Subject: Transmittal of Revision 1 to Service Bulletin Number
V2500-ENG-72-0132

International Aero Engines SERVICE BULLETIN

ENGINE - LP COMPRESSOR - REMOVAL OF
STAGE 6 BUFFER AIR SYSTEM

V2500 - ENG - 72 - 0132

Modification of the Fan Frame Assembly
Figure 1 (Sheet 1)

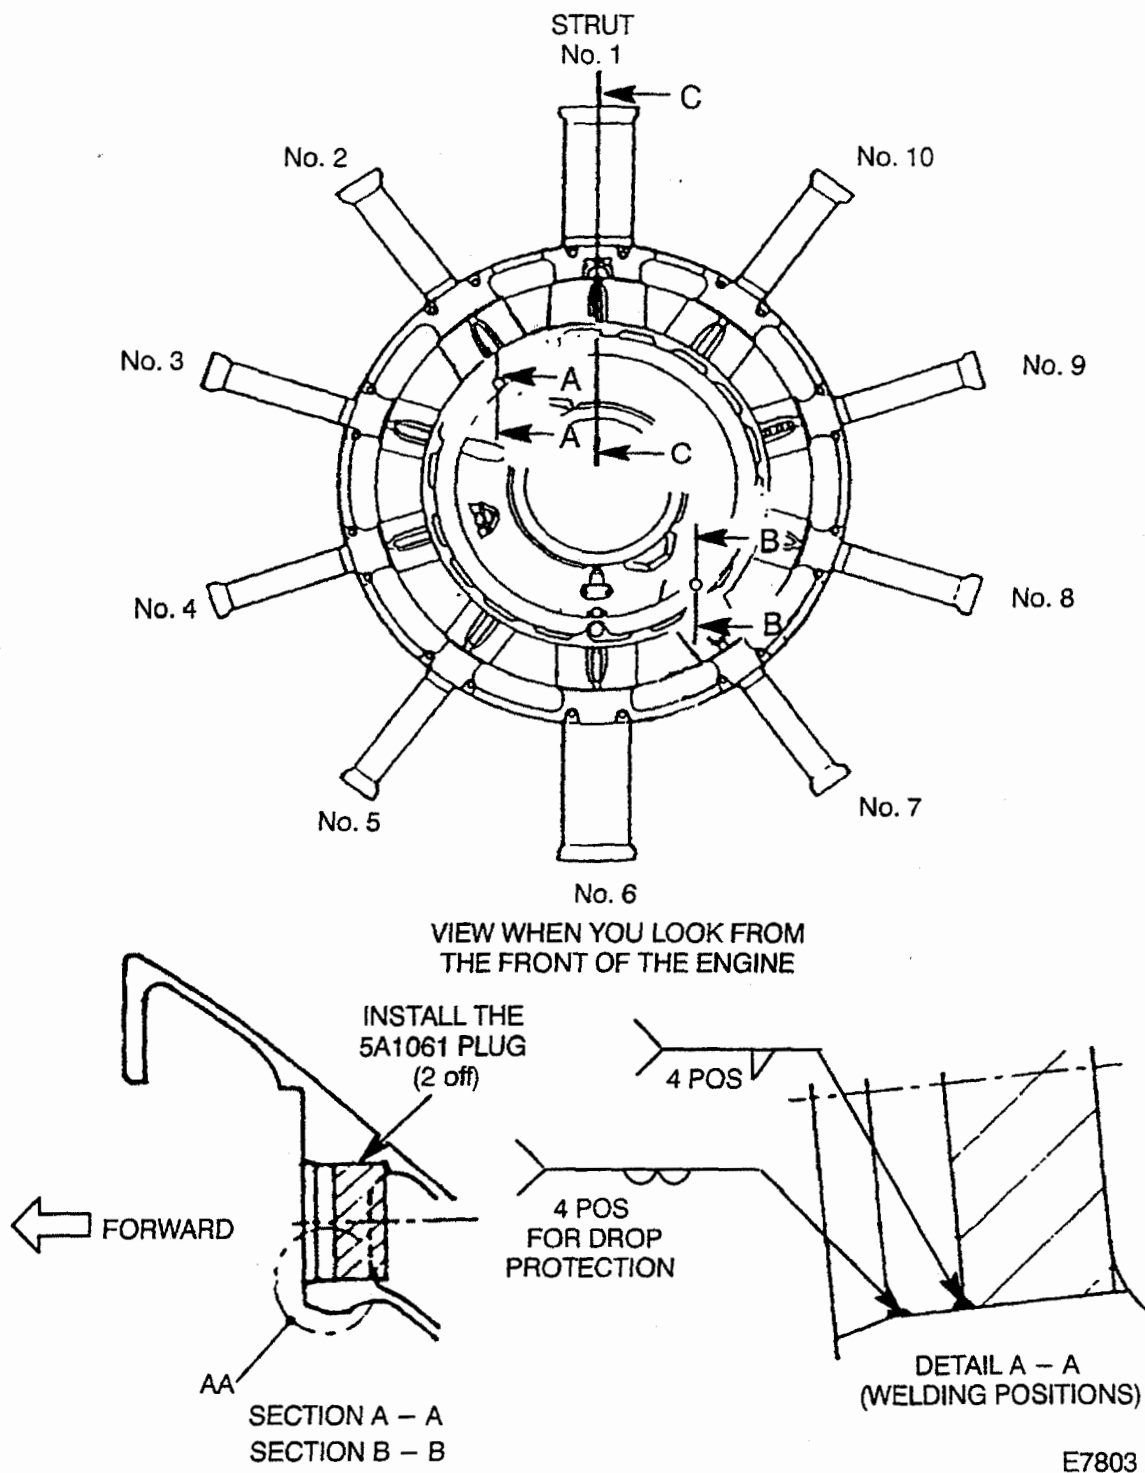
R	<u>Procedure</u>	<u>Supplementary Information</u>
R	(a) Clean the 5A1061 plugs (2 off)	Refer to reference (4), TASK
R	and the holes of the fan frame	72-11-26-300-503.
R	before welding.	
R	(b) Install the plugs into the holes	Refer to Figure 1, (Sheet
R	of fan frame, one of each part at	1 of 4) requirements.
R	two locations (2 off), and push	
R	plugs to the bottom of the holes.	
R	(c) Weld the plugs to the fan frame.	Refer to reference (4) TASK
R		70-31-02-310-501-001 ARGONARC
R		WELDING REPAIRS-01 and TASK
R		70-31-02-310-501-016. Use
R		CoMat 03-195 FILLER WIRE.
R	<u>NOTE:</u> The heat treatment is not necessary when this welding procedure was	
R	done, because this welded joint is defined by group 3.	
R	(d) Visually inspect welded area.	Refer to reference (4) TASK
R		70-31-02-310-501-001, SUBTASK
R		70-31-02-220-001 and
R		70-31-02-220-002.
R	(e) Put the fan frame on the milling	Refer to Figure 1 (Sheet 2 of

Modification of the Fan Frame Assembly
Figure 1 (Sheet 2)

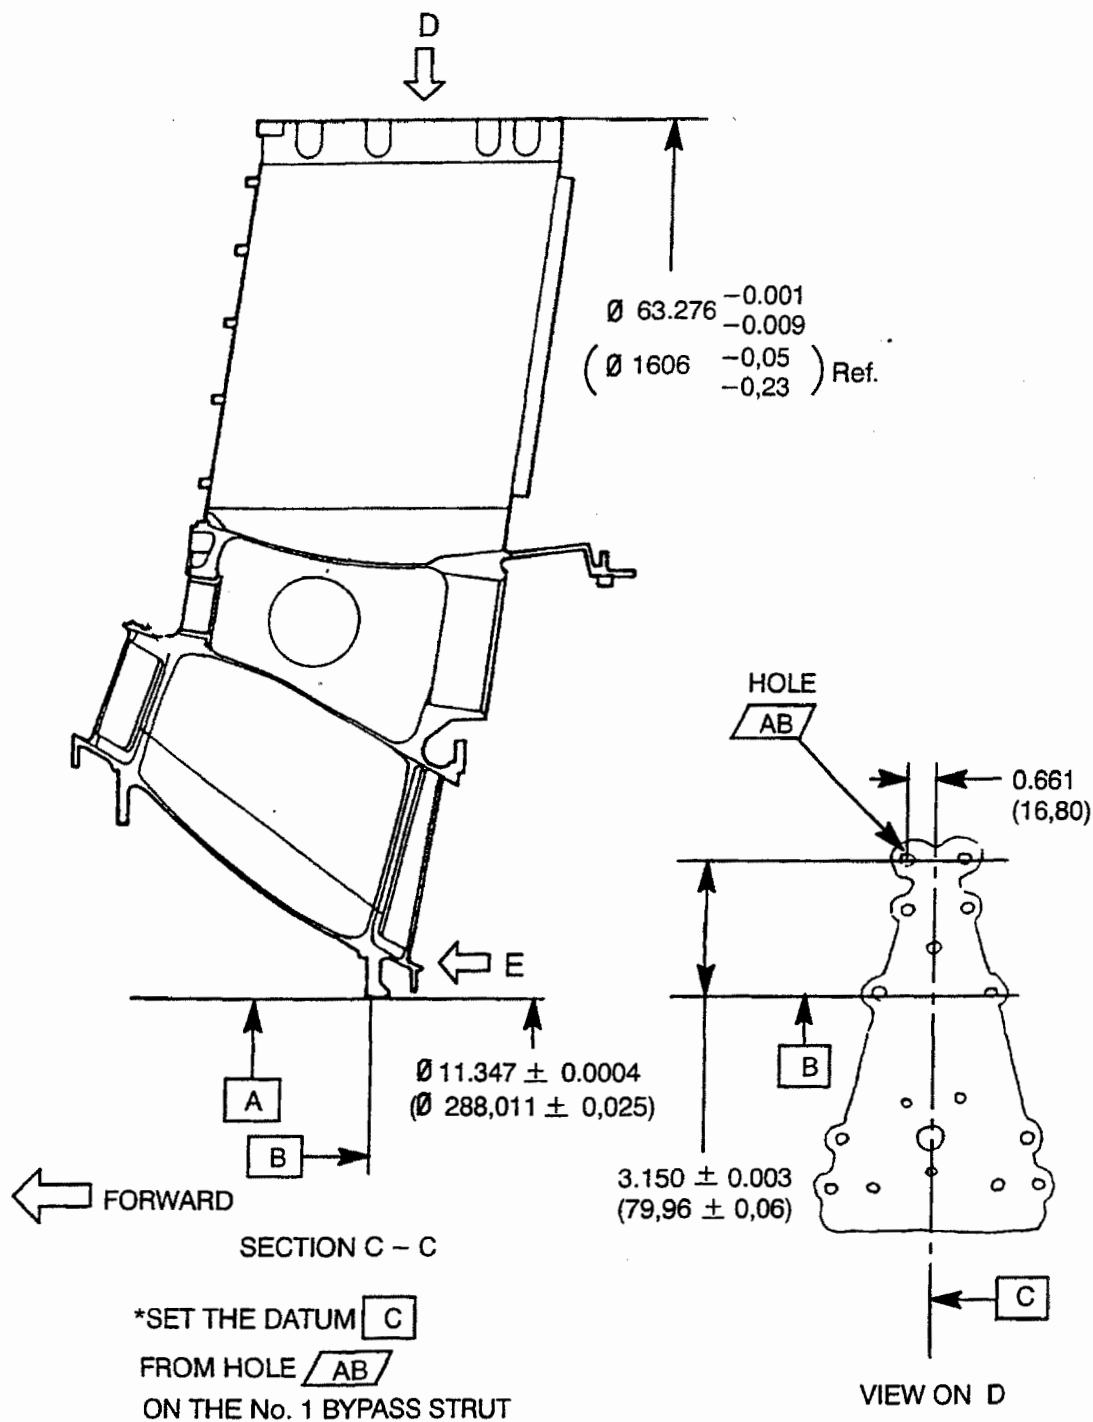
R	machine and set the datum using	of 4).
R	the smallest flange and a hole	
R	of No.1 bypass strut.	
R	(f) Cut a slot using a 0.206 in (5,25 mm)	Refer to Figure 1 (Sheet 3 or
R	or smaller diameter cutter.	of 4).
R	(g) Remove all sharp edges from area of	Use standard work shop
R	cut and make a smooth surface.	equipment.
R	(h) Clean the affected area.	Refer to reference (4), TASK
		70-11-26-300-503 solvent
		cleaning-03.

Location of the Ring Nut Assembly
Figure 1 (Sheet 4)

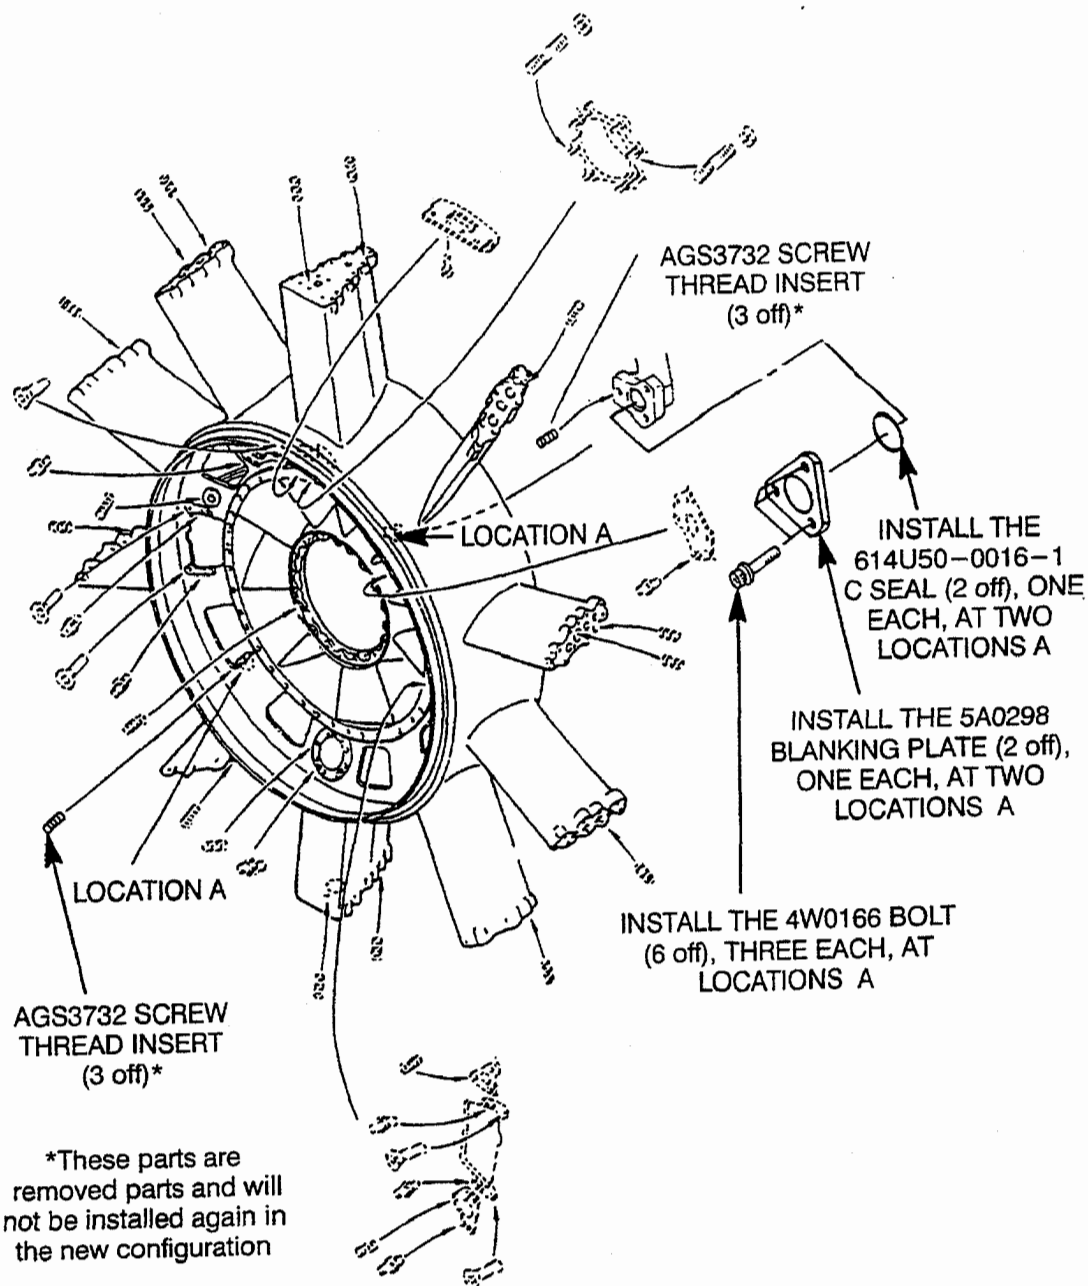
R (j) Install the 614U50-0016-1 C-seals
R (2 off) and the 5A0298 blanking
R plates (2 off), one of each part at
R two locations.

Refer to Figure 1 (Sheet 4 of
of 4).

Location of the Ring Nut Assembly
Figure 2

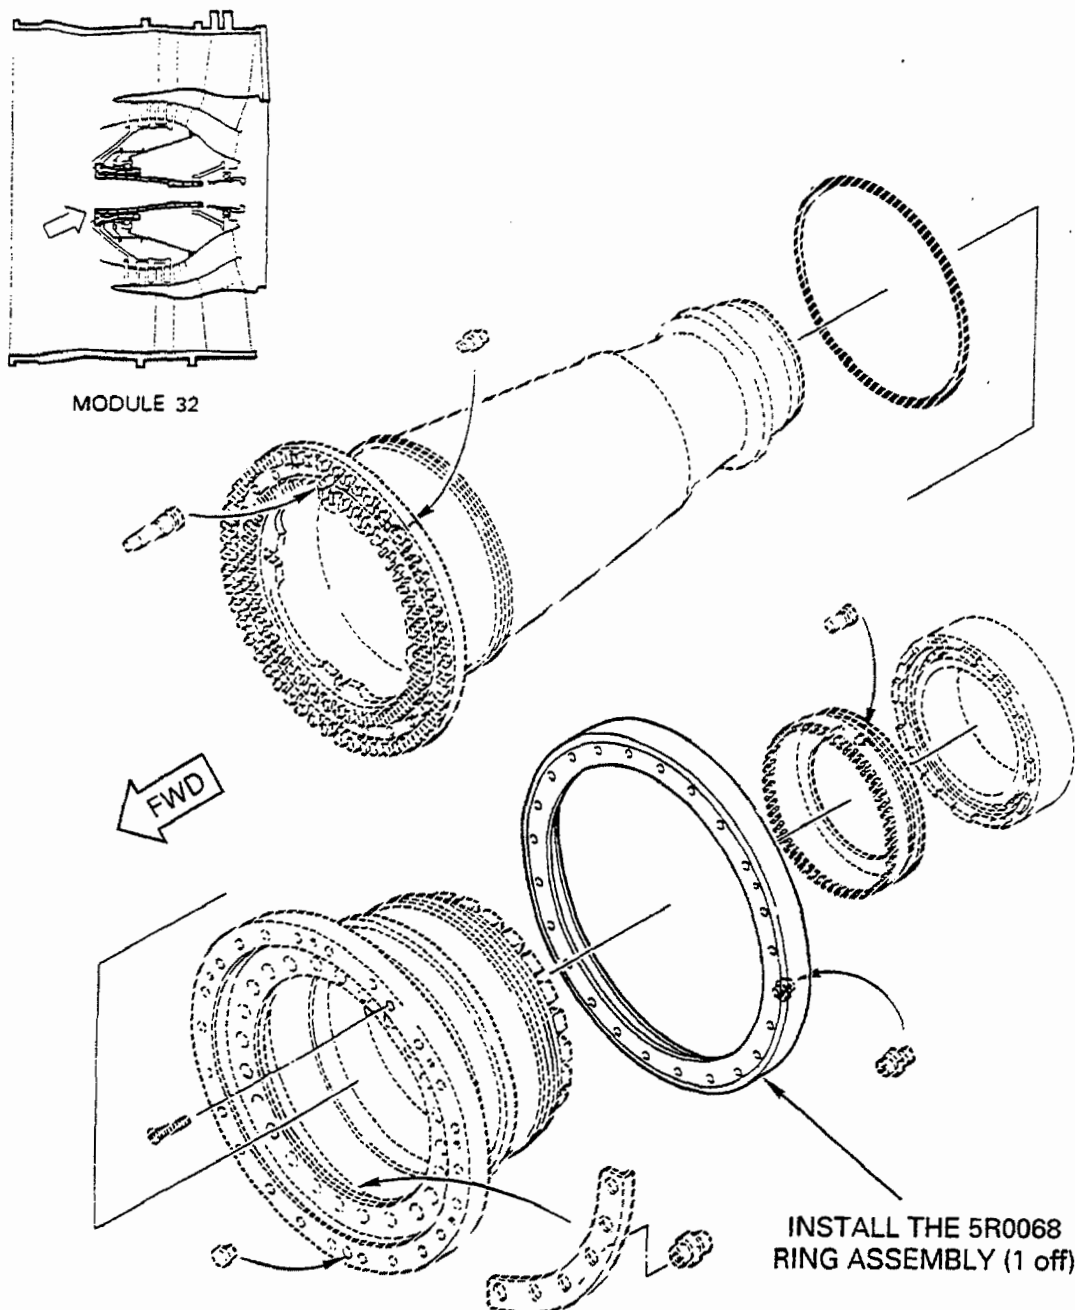
- (1) When you do the procedure given in Reference (3), Chapter/Section 72-32-20, Assembly, install the 5R0068 Ring Nut Assembly (1 off) and the 2A2370 No. 3 Bearing Seal Assembly (1 off). See Figures 2 and 3.
- (2) When you do the procedure given in Reference (3), Chapter/Section 72-32-50 install the 2A1065 No. 1 Bearing Seal Assembly (1 off) and the AS3209-279 Packing (1 off). See Figure 4.

Location of the Fan Frame Assembly
Figure 5

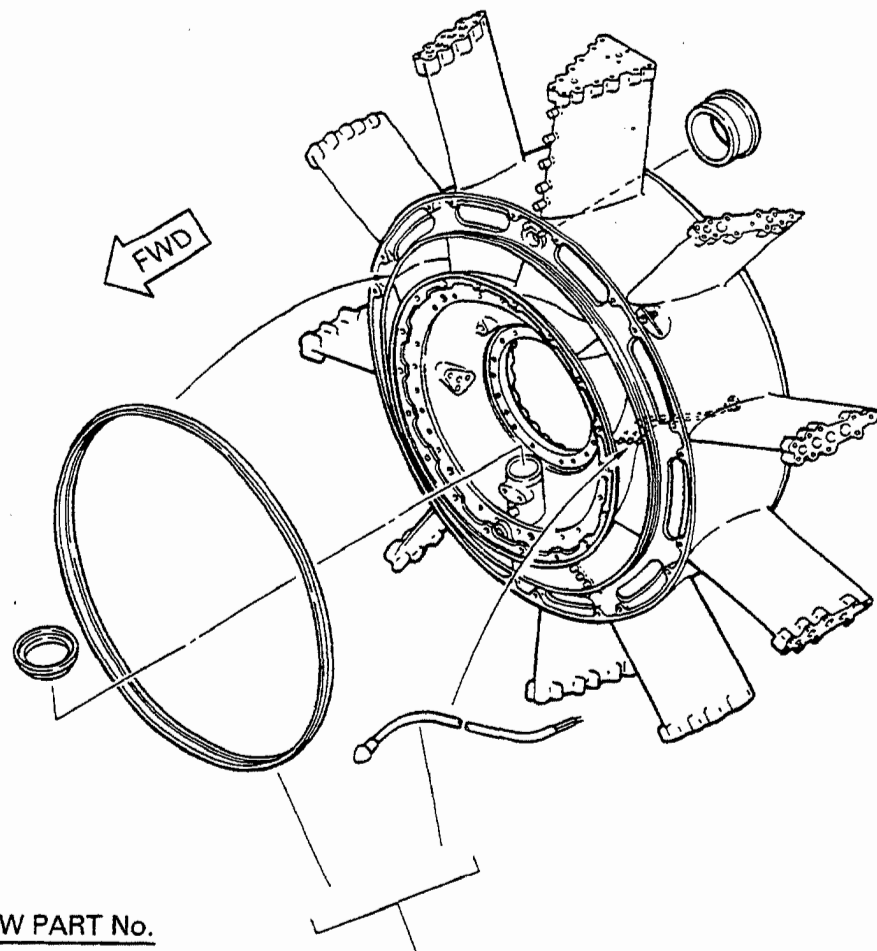
- (3) When you install the Fan Frame Assembly by the instructions given in Reference (3), Chapter/Section 72-32-00, Assembly-01, use one of the assemblies given below:

- (a) 5A1047 Fan Frame Assembly (1 off) or,
- (b) 5A1049 Fan Frame Assembly (1 off) or,
- (c) 5A1062 Fan Frame Assembly (1 off) or,
- (d) 5A1064 Fan Frame Assembly (1 off) or,
- (e) 5A1066 Fan Frame Assembly (1 off) or,
- (f) 5A1068 Fan Frame Assembly (1 off) or,
- (g) 5A1167 Fan Frame Assembly (1 off). See Figure 5.
